David J. Johnson
Director
Service Engineering Operations
Ford Customer Service Division

Ford Motor Company
P. O. Box 1904
Dearborn, Michigan 48121

December 11, 2019

**SUBJECT: NEW VEHICLE DEMONSTRATION / DELIVERY HOLD -
Safety Recall 19S34 – Supplement #4**
Certain 2019 Model Year Ranger Vehicles
HVAC Blower Motor Smoke/Fire

FIGURE 1

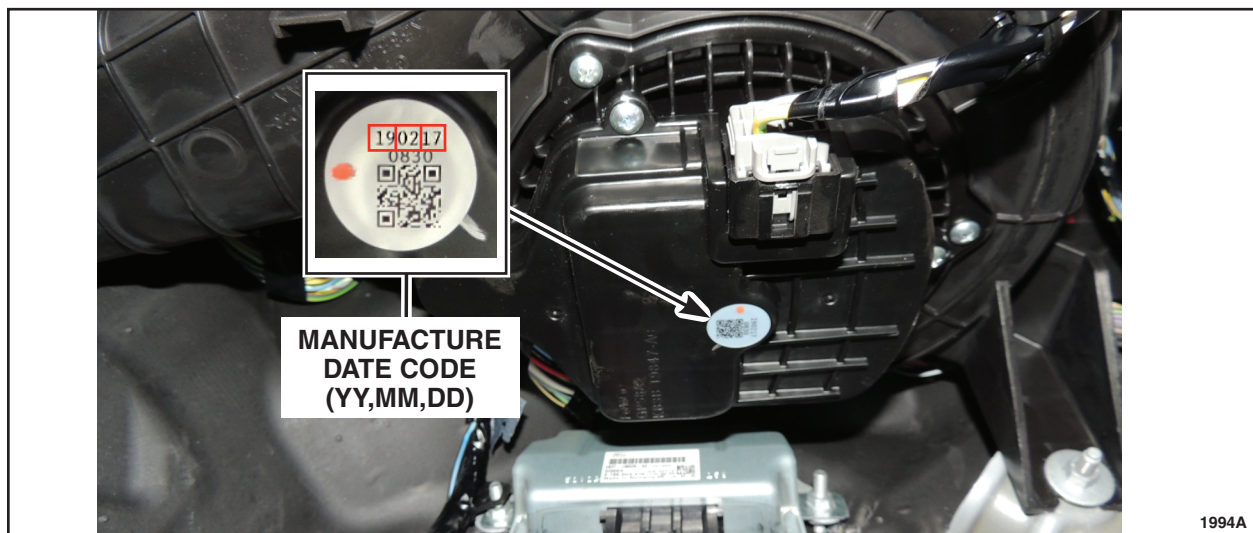
1. Using a camera, take a photo of the HVAC blower motor build date code. Review the date code. See Figure 1.

- Is the date code 190614 (June 14, 2019) through 190922 (September 22, 2019)?

Yes - Replace Blower Motor Module. Please follow the Workshop Manual (WSM) Section 412-00. Then proceed to Step 2.

No - Inspection is complete no further action required.

- All service parts ordered by dealer should be inspected for date codes.
- If you receive a service part with date codes between 190614 (June 14, 2019) through 190922 (September 22, 2019), do not install on vehicle.
- If you receive a service part within suspect date range above, please contact SSSC.
